# RENESAS TECHNICAL UPDATE

Product Category	MPU&MCU		Document No.	TN-SH7-A581A/E	Rev.	1.00
Title	Amendment of MultiMediaCard Interface		Information Category	Technical Notification		
Applicable Product	HD6417720	Lot No.	Reference Document	SH7720 hardware manual Rev2.00 ( REJ09B0033-0200 )		
		All

There are the amendments and additions of MultiMediaCard Interface of SH7720 hardware manual Rev2.00.

## 1. Page 1024 of 1382, Section 31

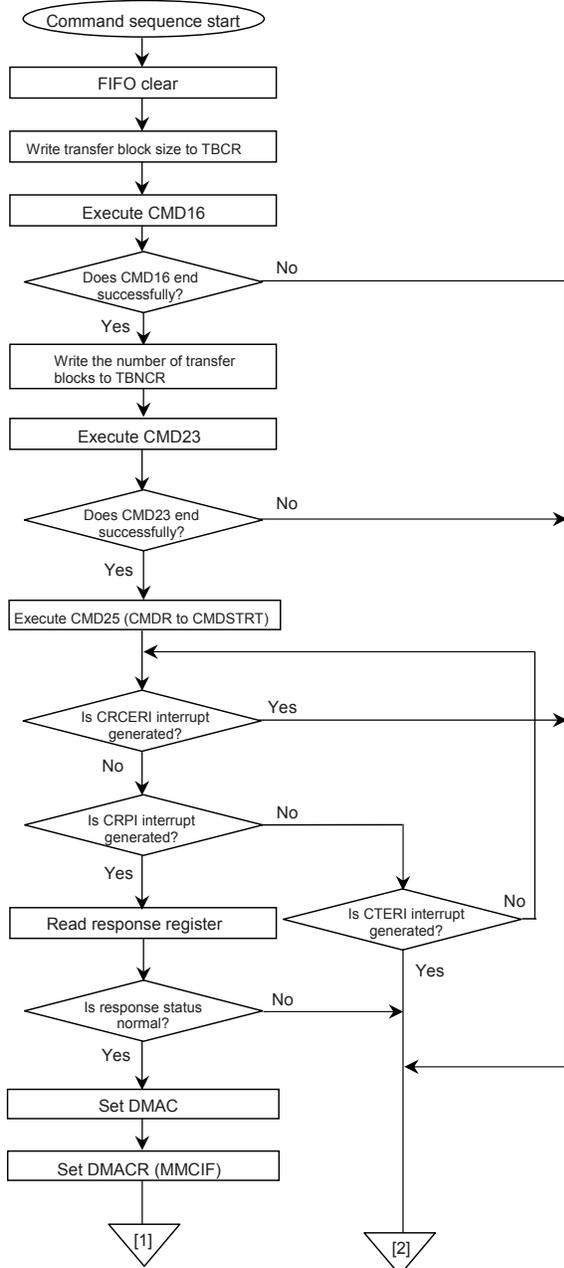
Original:

DMAEN sets DMA request signal output. DMAEN enables/disables a DMA request signal. The DMA request signal is output by a value that has been set to bits SET2 to SET0.

Amended:

DMAEN sets DMA request signal output. DMAEN enables/disables a DMA request signal. The DMA request signal is output by a value that has been set to bits SET2 to SET0.

Before executing a command (CMD18, CMD25) in the multiblock transfer, this register should be set.

Auto mode is not used in open-ended multi block transfer.
